RE: LAND OFF BASINGSTOKE ROAD, SPENCERS WOOD (APP NO: 250517)

ECOLOGICAL IMPACT ASSESSMENT & BIODIVERSITY IMPACT ASSESSMENT TECHNICAL ADDENDUM NOTE

Figure 5.9: Illustrative Landscape Masterplan

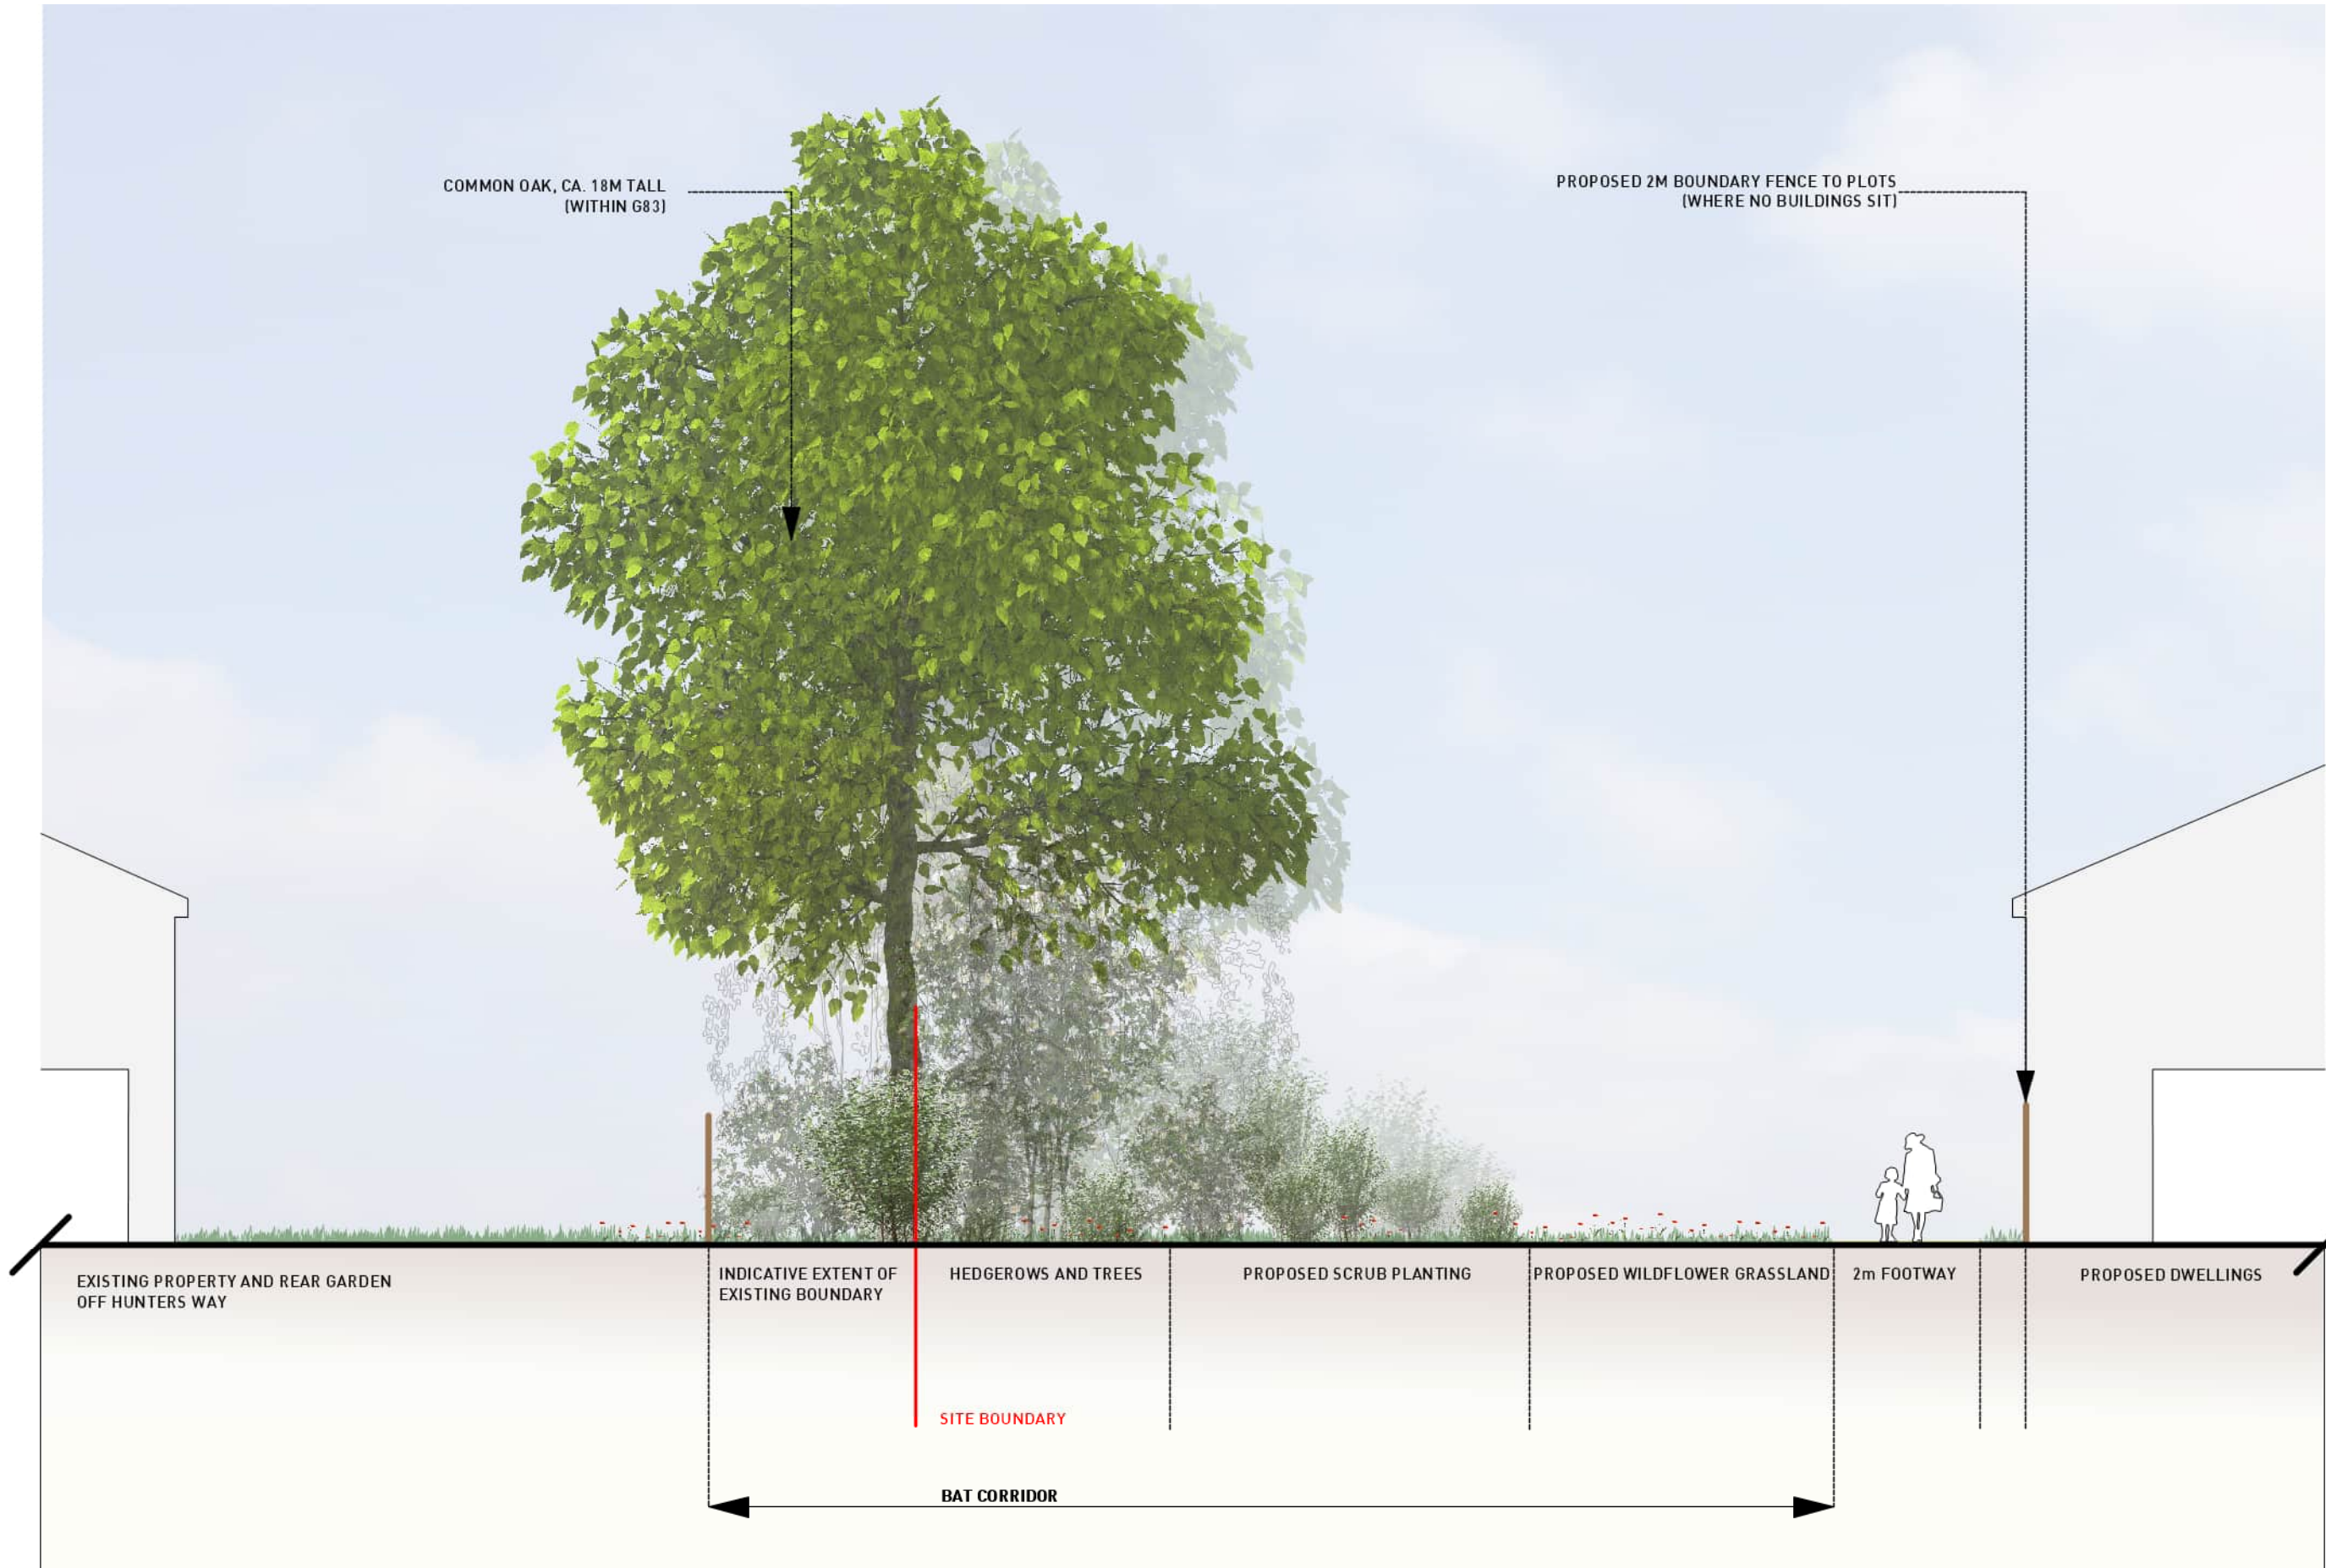
"I agree that the assemblage of bat species recorded on-site is not of county significance. The use of the northern perimeter of the site by Barbastelle bat is important, though. This species is classified as vulnerable in England under IUCN classification and it will be important to assess the impact of the proposals on the local conservation status of this species carefully. I agree that currently the site is likely only of interest to the species as a commuting route. This is a light sensitive species and vegetated boundary likely provides a dark corridor between parkland (to the West) and the river Loddon (to the East). The mitigation proposals are to strengthen the vegetated corridor along the northern boundary in order to retain a commuting corridor between the new development and the existing development to the North. I accept that this could be possible but I am concerned that the current Parameters Plan and Illustrative Landscape Masterplan do not show the space being reserved for this mitigation measure. It would be helpful to have an example cross section of how the wildlife corridor

is proposed to be retained and enhanced at this stage to set the minimum standard when it comes to future detailed design at reserved matters”.

RammSanderson can confirm that the Applicant's submissions plans have been updated and now show a continuous green corridor along the northern boundary of the Scheme which directly connects to the SANG to the east and other areas of open green space to the west. For reference, the updated Illustrative Landscape Masterplan is presented in Appendix 1a of this letter report together with a cross-section of the green corridor (Appendix 1b) indicating how it is proposed to be retained and enhanced.
